RE: **Lot 13 Block 1 Volcano Cliffs Unit 22 SAD 228
8001 Alto Rey Ct. NW
Grading and Drainage Plan
Engineers Stamp Date 10/21/2020 (D10D003N13)
Pad Certification Dated: 5/10/2021**

Based upon the information provided in your submittal received 6/25/2021, this plan is approved for Building Permit.

SHEET TITLE: GRADING AND DRAINAGE PLAN

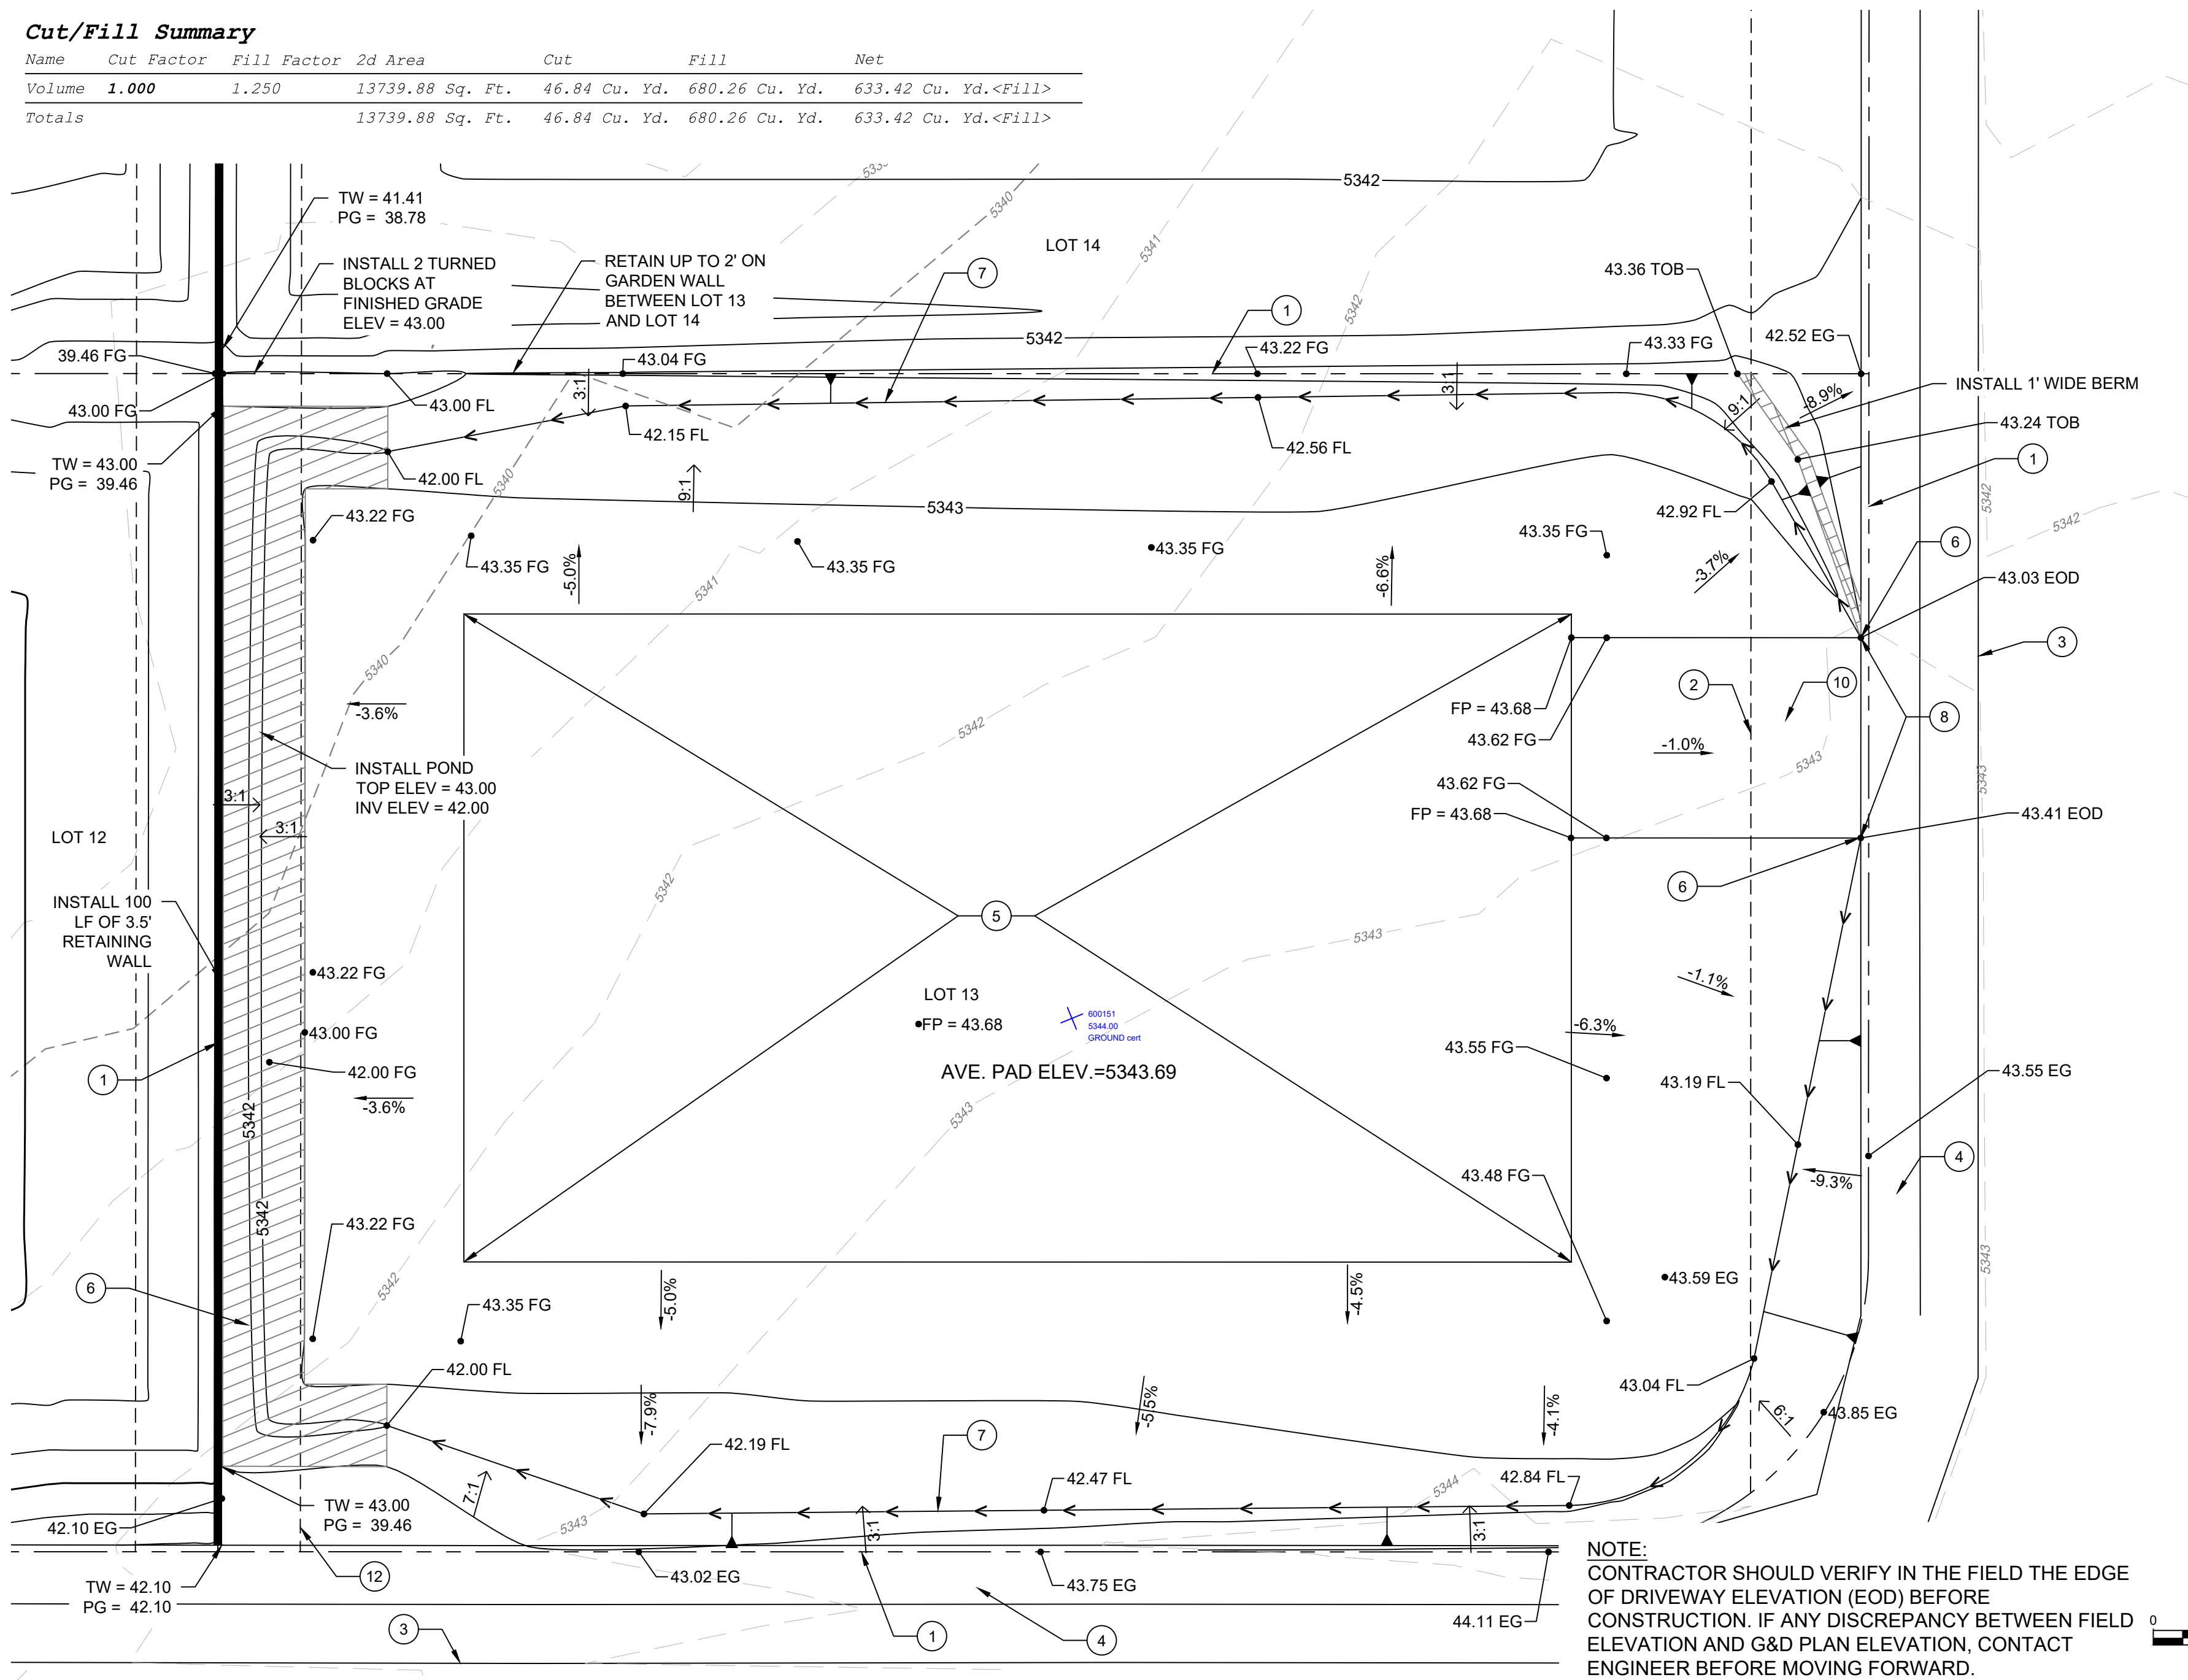
Reiterate to the Owner/Contractor that a separate permit for a garden/retaining wall must be obtained with the approved G&D plan and Pad Certification. **Also, if a swimming pool is to be placed the grading and drainage plan will change and will need to be resubmitted showing location of pool and land treatment changes.**
